# 1998 Corvette Convertible: Service Bulletin: Tonneau Cover Makes Noise When Going Over Bumps

**Subject:** TONNEAU COVER MAKES NOISE WHEN GOING OVER BUMPS  
(INSTALL TAPE)

**Number:** 83-15-06 - (04/22/1998)

**Models:** 1998 CHEVROLET CORVETTE CONVERTIBLE

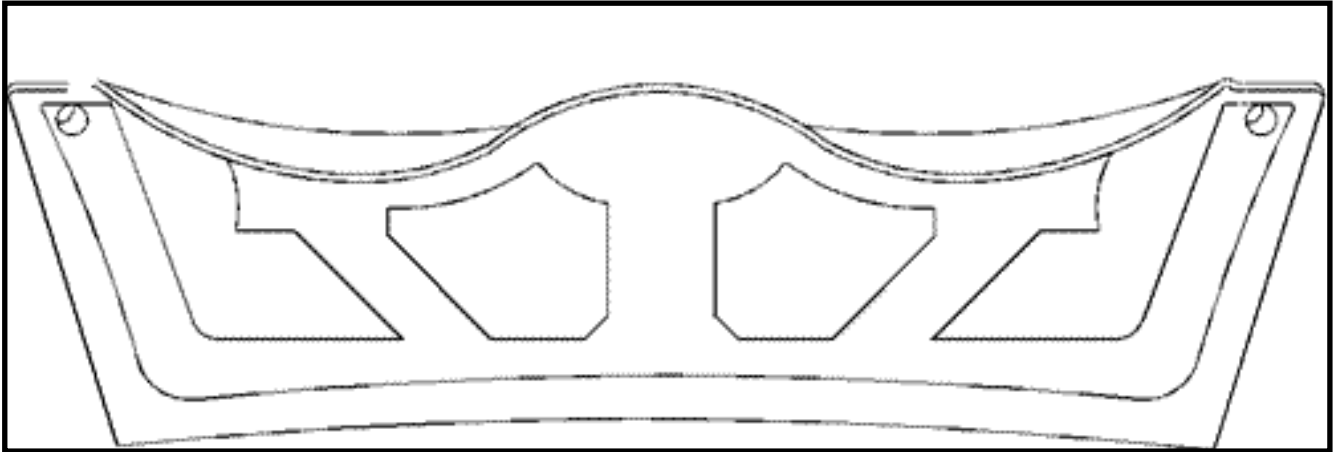
SOME CUSTOMERS MAY COMMENT THAT THE TONNEAU COVER MAKES NOISE WHEN GOING OVER BUMPS, WITH TOP IN THE UP POSITION.

THIS SITUATION MAY BE CAUSED BY THE RUBBER STOP BUMPERS HAVING A STICK/SLIP CONDITION TO THE TONNEAU COVER.

1. CLEAN TONNEAU COVER IN THE AREA SHOWN (FIGURE 1) WITH A GENERAL PURPOSE CLEANER.
2. INSTALL A PIECE OF 3M(R) SCOTCH SQUEAK REDUCTION TAPE (P/N 06356), OR EQUIVALENT, TO THE TONNEAU COVER.
